Subject: Story Avenue and Main Street Storage Basin
Minor Project Modification
IOAP Project No. L_OR_MF_020_S_09B_B_A_8
DOJ Case No. 90-5-1-1-08254

MSD is requesting approval of a proposed minor project modification to the Story Avenue and Main Street Storage Basin project (IOAP Project No. L_OR_MF_020_S_09B_B_A_8). This modification is part of an overall adaptive management review of the approved 2009 IOAP that will be documented in the proposed 2012 IOAP Modification to be formally submitted in 2013. Since the project modifications will affect MSD's implementation activities prior formal submittal of the revision documentation, approval of the proposed modification is requested at this time.

Ohio River
Solution ID # L_OR_MF_020_S_09B_B_A_8
Story Avenue and Main Street Storage Basin

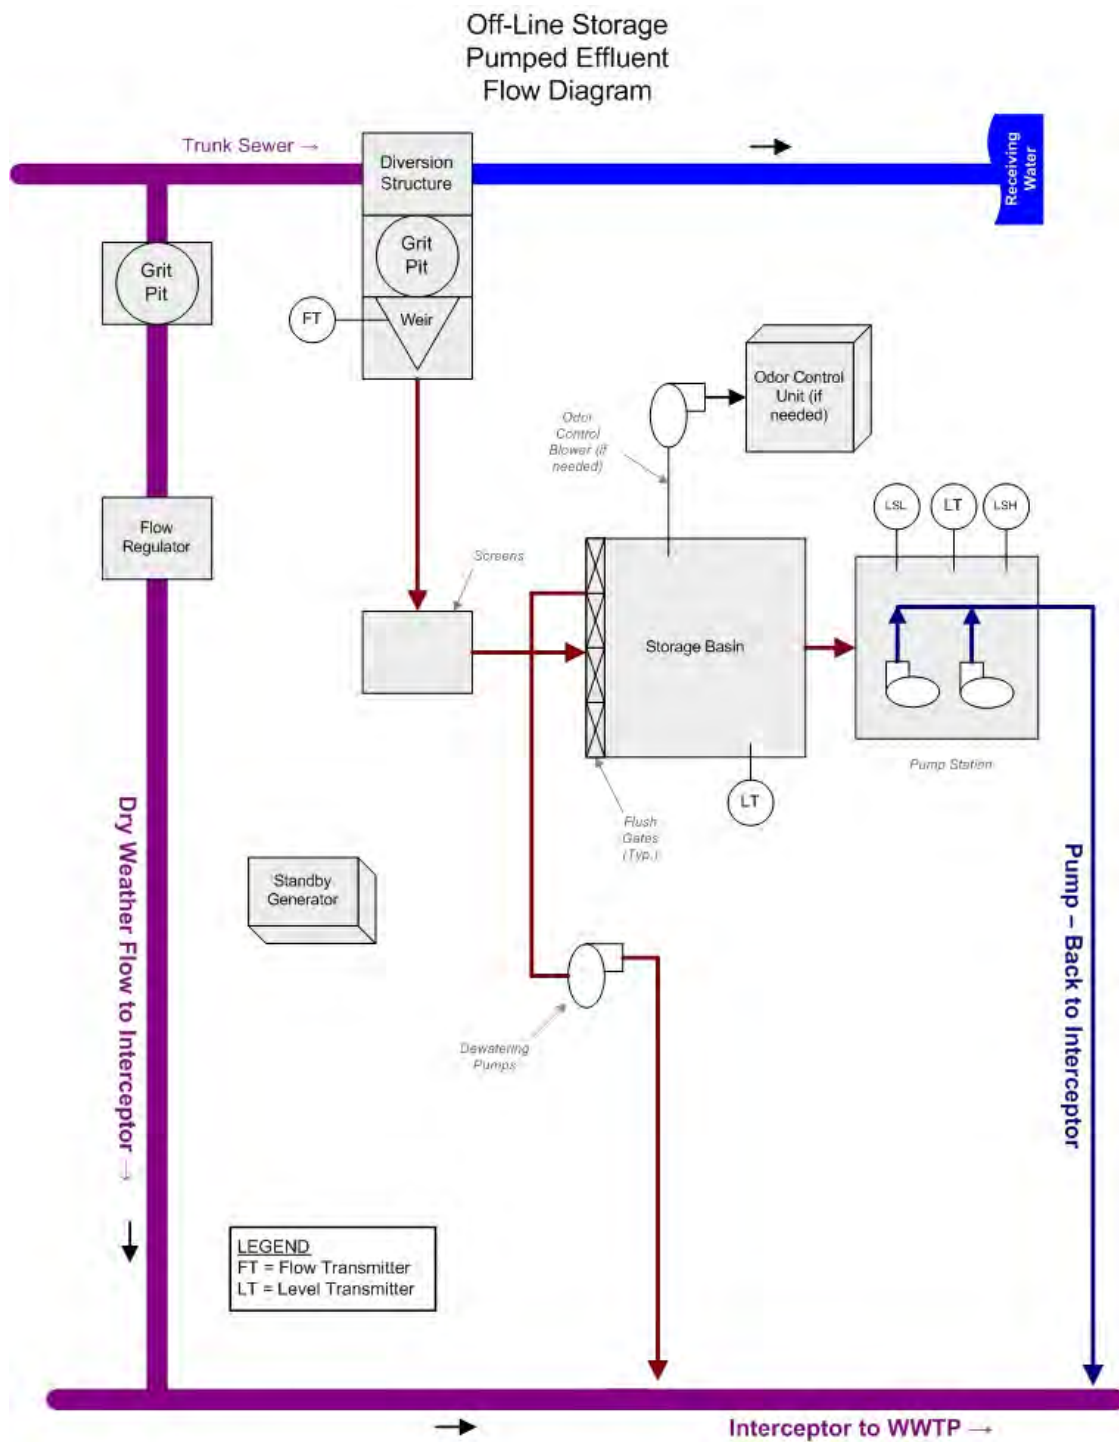
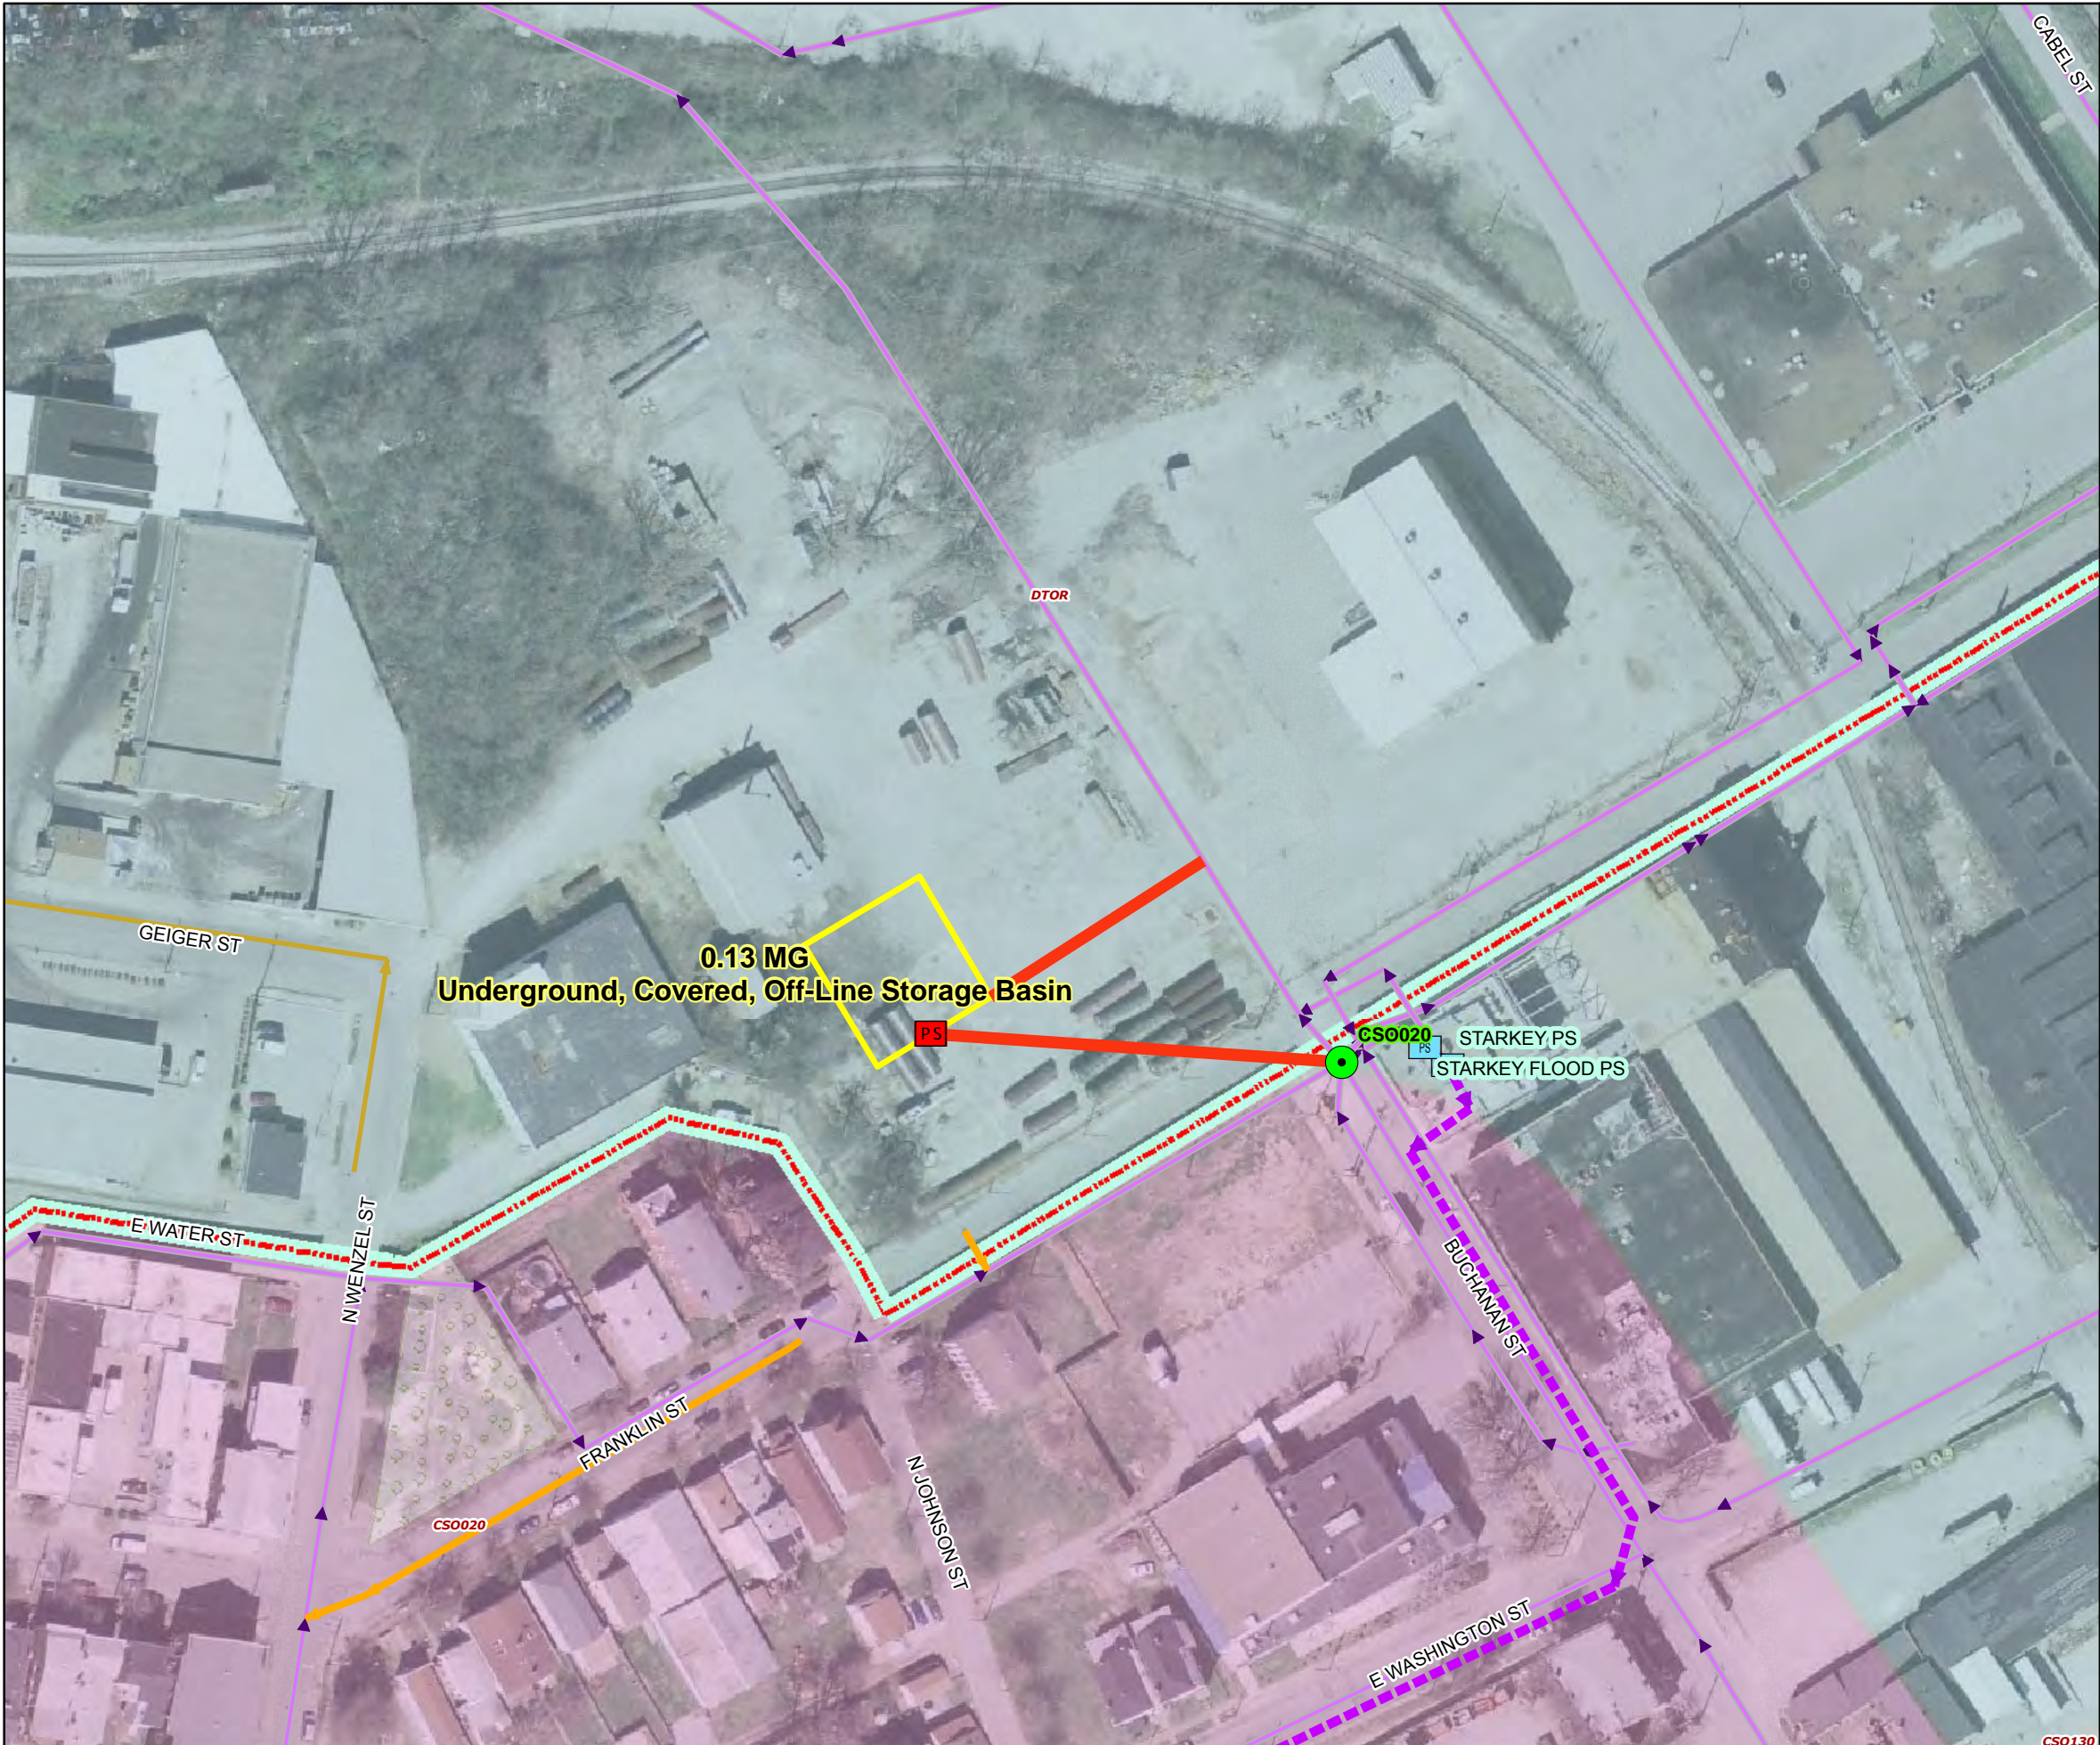
The Story Avenue and Main Street Storage Basin project entailed the construction of a 0.13 million gallon (MG), off-line storage basin adjacent to the Starkey Pump Station to be completed by December 31, 2013. The project controlled CSO 020 to an eight overflow per typical year level of control.

Project Description: This project includes the construction of a 0.13 MG off-line underground covered storage basin for CSO020 to reduce overflows to 8 overflows per year. The facility will require a 0.13 MGD PS the stored flow to the RSPS following the wet weather event.

The project modification involves the construction of a 5.42 MG, off-line storage basin adjacent to the Starkey Pump Station to be completed by December 31, 2020. The project will control CSO 020 to an eight overflows per typical year level of control.

Project Description: This project includes the construction of a 5.42 MG off-line underground covered storage basin for CSO020 to reduce overflows to 8 overflows per typical year. Project assumes that the Starkey Pump Station has a typical, minimum pumping rate of 108 MGD. Additional storage or a higher pump-out rate may be added if deemed advantageous to operational and maintenance flexibility as well as impacts to other downstream CSO control projects.
